Access Compliance Report Public Rights-of-Way (Curb Ramps)

Intersection ID: 10029218 Main Street: JOHNSON_AND_WALES_WY Cross Street: N/A Location: Ε

Overall Compliance: No ADA ID: 962A985AB029 Ramp Type: Perp Initial Pass/Fail: Fail **Severity Score:** 12.5

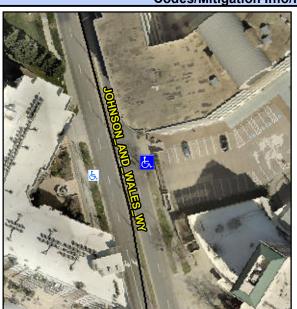
Field Measurements/Component Compliance								
Compl	iance Description	Data	Compl	iance	Description	Data		
N/A	Ramp Length (in)	88.0	Yes	Ramp	Slope (%)	5.9		
Yes	Ramp Width (in)	72.5	No	Ramp	XSlope (%)	5.6		
N/A	Flare Type LT	N/A	N/A	Flare	Type RT	N/A		
N/A	Flare Slope LT (%)	N/A	N/A	Flare	Slope RT (%)	N/A		
N/A	Flare Traversable LT?	N/A	N/A	Flare	Traversable RT?	N/A		
N/A	Landing Length (in)	N/A	N/A	DWS	Provided?	N/A		
N/A	Landing Width (in)	N/A	N/A	DWS	Contrast?	N/A		
N/A	Landing Slope (%)	N/A	N/A	DWS	Length (in)	N/A		
N/A	Landing X Slope (%)	N/A	N/A	DWS	Full Width?	N/A		
N/A	Landing Curb? (Y/N)	N/A	N/A	DWS	Offset (in)	N/A		
N/A	Shared Landing?	N/A						
N/A	Gutter Ponding?	N/A	N/A	Gutte	r Slope (%)	N/A		
N/A	Gutter Lip Ht (in)	N/A	N/A	Gutte	er X Slope (%)	N/A		
N/A	Painted X Walk1?	No	N/A	Paint	ed X Walk2?	N/A		
	X Walk 1 Direction	To W		X Wa	lk 2 Direction	N/A		
N/A	X Walk 1 Width (in)	N/A	N/A	X Wa	lk 2 Width (in)	N/A

•
Possible Solutions:	
Remove & Replace Entire Ramp.	
•	
Surveyor Notes:	
N/A	
N/A	
PROW/ADA:	
R304.5.3	
K304.5.3
